VILLAGE OF THIENSVILLE
PLAN COMMISSION
AGENDA

DATE: Tuesday, February 4, 2020 LOCATION: Village of Thiensville
250 Elm Street
TIME: 6:00 PM
CALL TO ORDER

B. Review And Approval Of Gordie Boucher Alteration/Renovation, 101 North Main Street

D. Review And Approval Of Pro Health Chiropractic, Architectural, Site And Exterior Lighting, 407 North Main Street

Drawing Title:
DEMO /
PROPOSED
SOUTH ELEV.

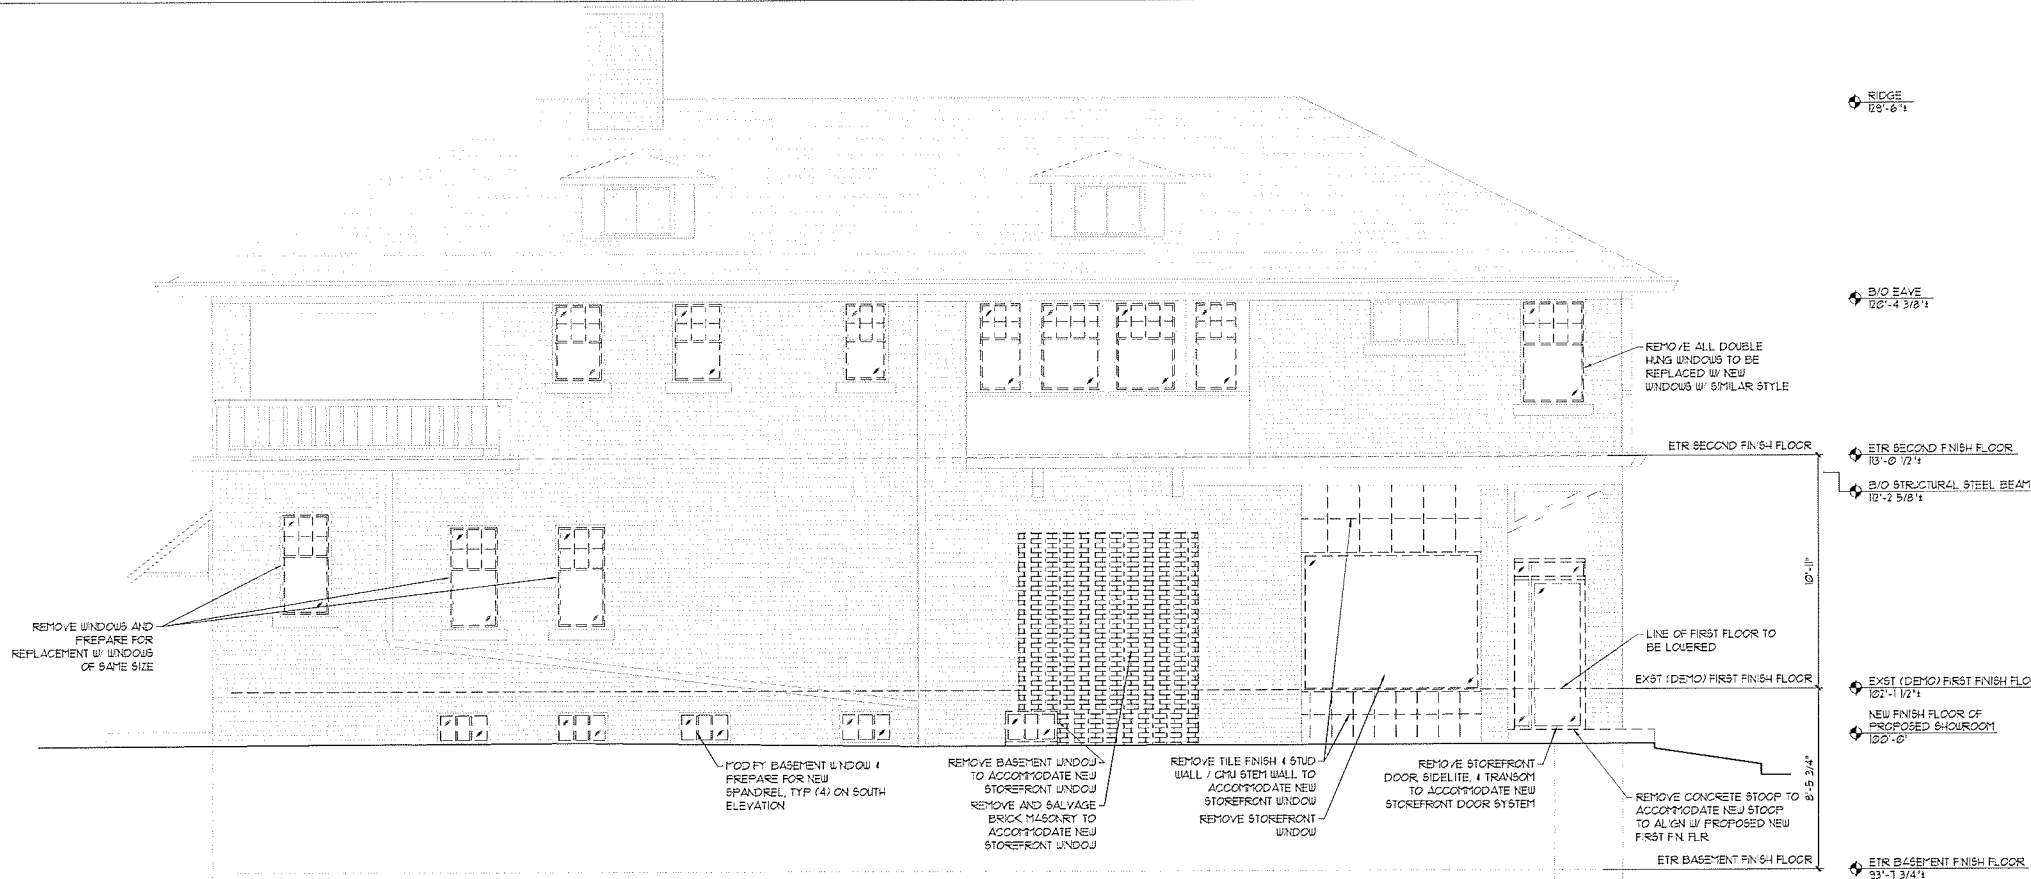
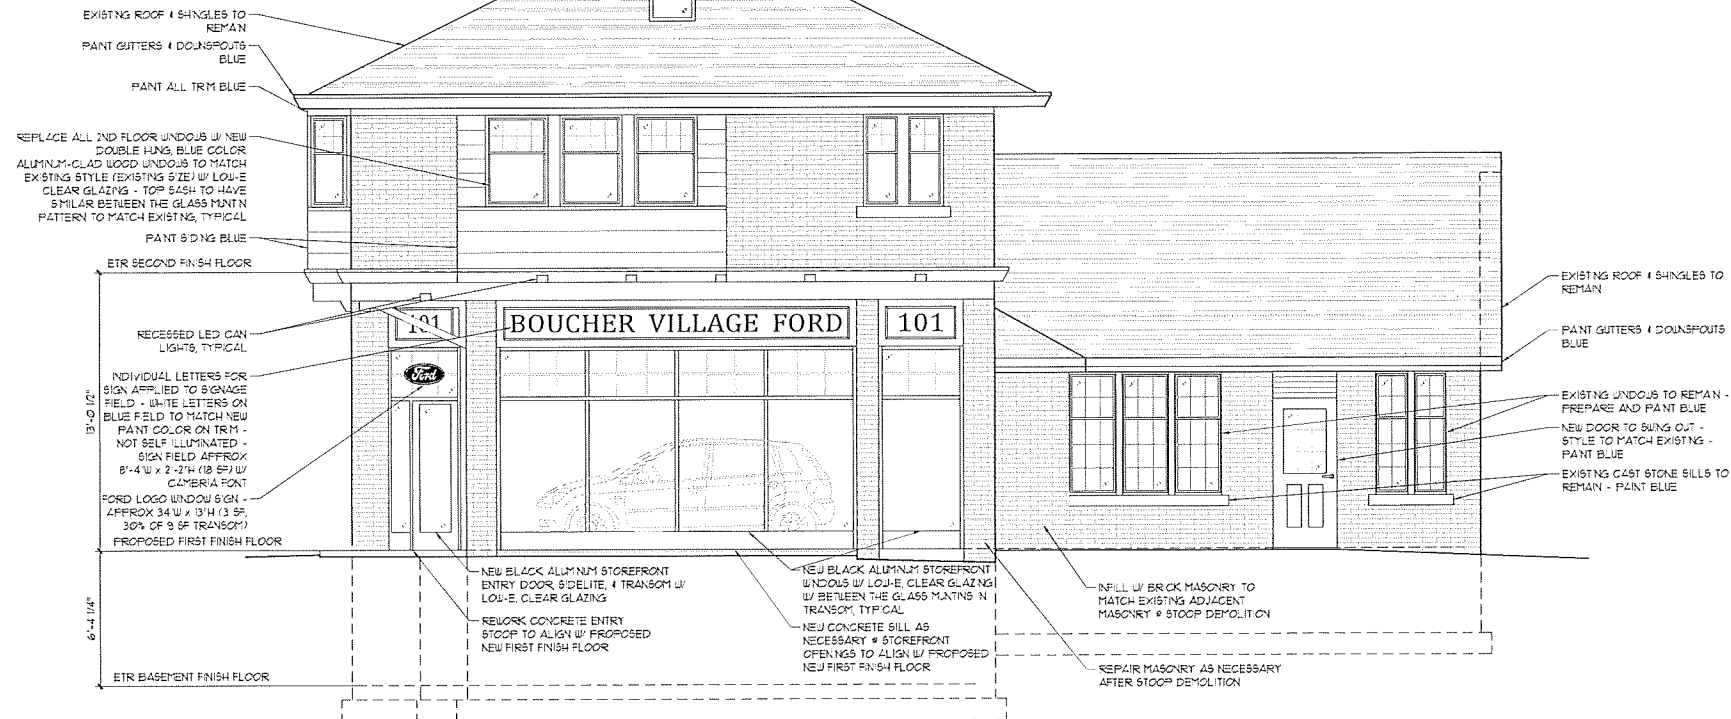
Accordingly, since the applicant is proposing two signs on this building that exceeds the maximum permitted, the applicant is requesting a Sign Code waiver. **Section 16.24 - Variances, does provide the Plan Commission permission to consider such a waiver if, in your judgment, a waiver or modification to the provisions of this chapter would further the public interests.**

When considering a Sign Code waiver of this nature the applicant must provide justification that the waiver is critical to further the public interest. With all the existing signs currently on display at this site, this Planner feels that the site is more than adequately identified and therefore my recommendation is that the new sign on the east elevation be reduced to no larger than 15 square feet in size. Staff has no objection to allowing the proposed sign on the south façade by waiver.

1 SITE PLAN - ARCHITECTURAL SITE PLAN
1/8" = 1'-0"

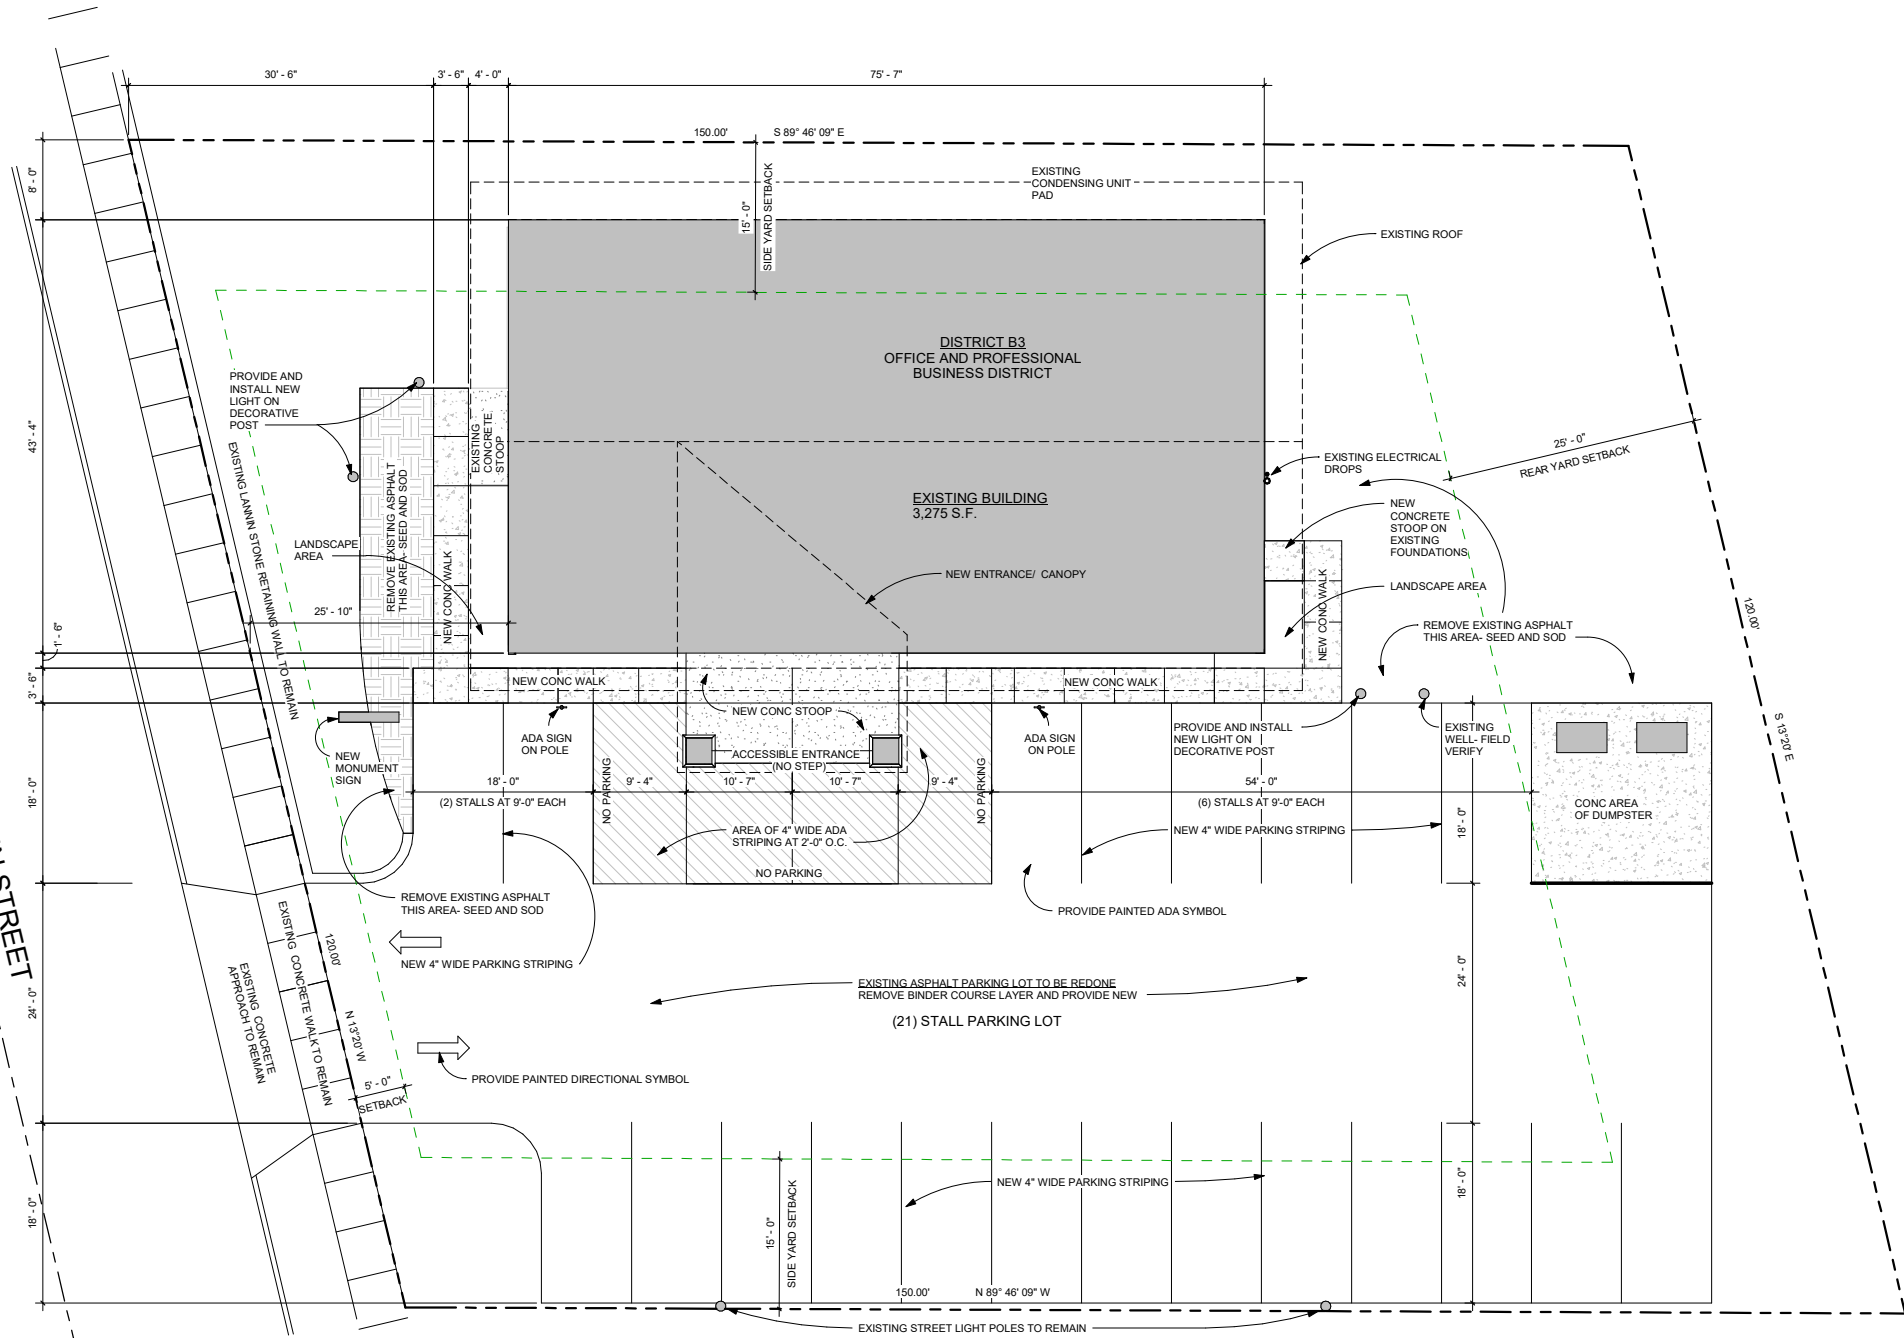
The new site layout includes a new sidewalk that extends across the north side of the building and wraps around to the east and west side back to the existing doors. The only change to the parking and traffic circulation is the elimination of four parking stalls adjacent to the main entrance. A new concrete dumpster pad will be installed at the southwest corner of the parking lot however no screening is shown on the plan. Staff recommends that a dumpster screening plan be submitted for staff approval.

Two new lights will be installed on decorative post adjacent to the sidewalk on the east side of the building to illuminate the sidewalk and one new is to be install off the northwest corner of the building. The applicant should provide the cut-sheets for these lights identifying the intensity, style and height of these fixture.

The plan indicates that a new monument sign is proposed but no information is provided. Accordingly, the applicant will need to submit his detailed sign plan for you review and approval.

- The applicant shall submit a dumpster screening plan.
- The applicant submitting the exterior lighting cut-sheets.
- The applicant securing a building permit prior to construction.
